UNITED STATES PATENT AND TRADEMARK OFFICE

09/808,253

Office Action Summary

TAGAWA ET AL.

FIG. 1 5,800,935

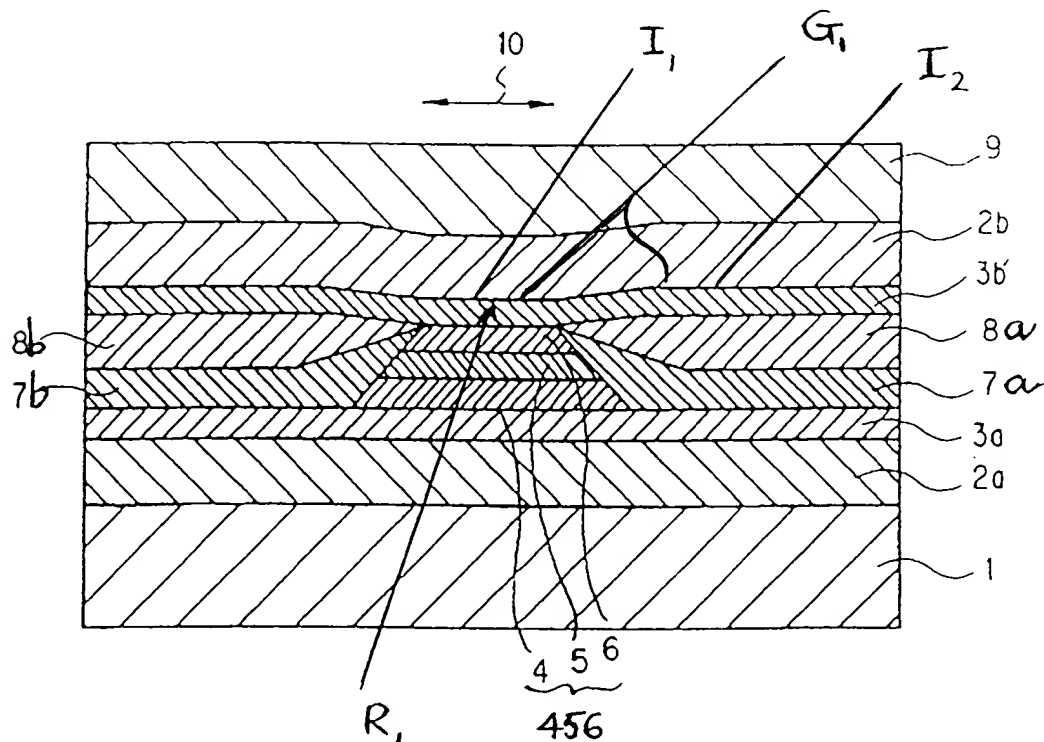
3. The text of those sections of Title 35, U.S. Code not included in this action can be found in a prior Office action.
4. Claim 17 is rejected under 35 U.S.C. 102(b) as being anticipated by Ishi (US 5,800,935). Ishi discloses, as in FIG. 1, a magnetoresistive transducer including a MR film 456 (see FIG. below) extending over a surface of a fundamental layer 3a; a pair of domain control layers 7a, 7b extending over the surface of the fundamental layer 3a so as to interpose the MR film 456 along the fundamental layer 3a, and an upper shield layer 2b opposed to the MR film at a first interface I_1 ; the upper shield layer 2b opposed to the domain control layers 7a, 7b at a second interface I_2 ; a groove G_1 between the first and second interface on the upper shield layer so as to isolate the first and second interface.

A...Applicant asserts that "the Ishi reference does not disclose a groove that isolates the first and second interfaces from each other." In response, in so far as the "groove" has been structurally defined in the claim, the Examiner considers the rising of the lower side of the shield layer 2b to encompass a "groove".
